T ECHNICAL INFORMATION

- Subject** ▶ 1) Change of Armature Assembly, Shoulder Sleeve 7, Flat Washer 6, Hex. Nut M6
2) Addition of Flat Washer 7
- For Models** ▶ HR3000C, HR3550C
- Country** ▶ All countries
- Description** ▶ The subject changes have been implemented as illustrated below.

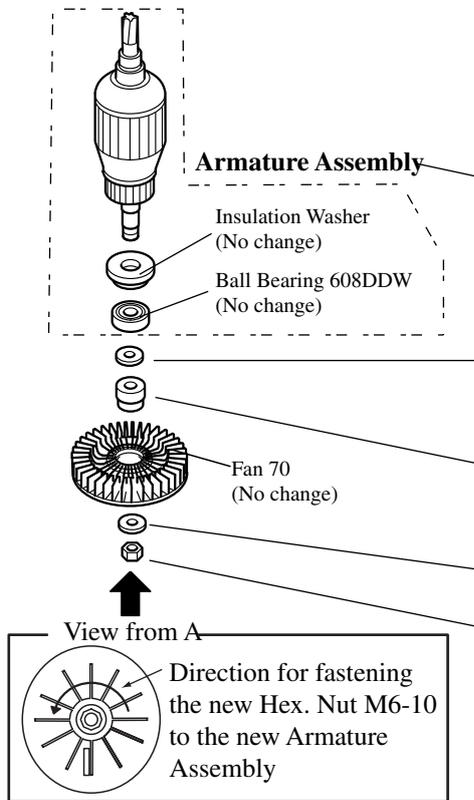
▶ Current	▶ New
Change of the thread of Armature Shaft (A constituent part of Armature Assembly)	Right hand thread 516380-9 (for Taiwan) 516381-7 (for 115V countries) 516383-3 (for 220V-240V countries)	Left hand thread 513515-3 (for Taiwan) 513516-1 (for 115V countries) 513518-7 (for 220V-240V countries)
Addition of Flat Washer 7	N/A	253133-2
Change of Shoulder Sleeve 7: See note below.	14mm (9/16") (323937-7)	13mm (1/2") (324261-1)
Change of Flat Washer 6	253047-5	941151-9
Change of Hex. Nut M6	Right hand thread (931302-2)	Left hand thread (252153-3)

Item No.	Current part	Q'ty	I/C	New part	Q'ty	Note
134	Flat Washer 7			Flat Washer 7 253133-2	1	Interchangeable as a set
124	Shoulder Sleeve 7 323937-7	1	No	Shoulder Sleeve 7 324261-1	1	
126	Flat Washer 6 253047-5	1	←	Flat Washer 6 941151-9	1	
127	Hex. Nut M6 931302-2	1	No	Hex. Nut M6-10 252153-3	1	
114	Armature Assembly 100V 516380-9	1	No	Armature Assembly 100V 513515-3	1	Taiwan only
114	Armature Assembly 115V 516381-7	1	No	Armature Assembly 115V 513516-1	1	Interchangeable as a set including Hex. Nut M6-10
114	Armature Assembly 220V-240V 516383-3	1	No	Armature Assembly 220V-240V 513518-7	1

When replacing Shoulder Sleeve 7, also replace Fan 70 at the same time.
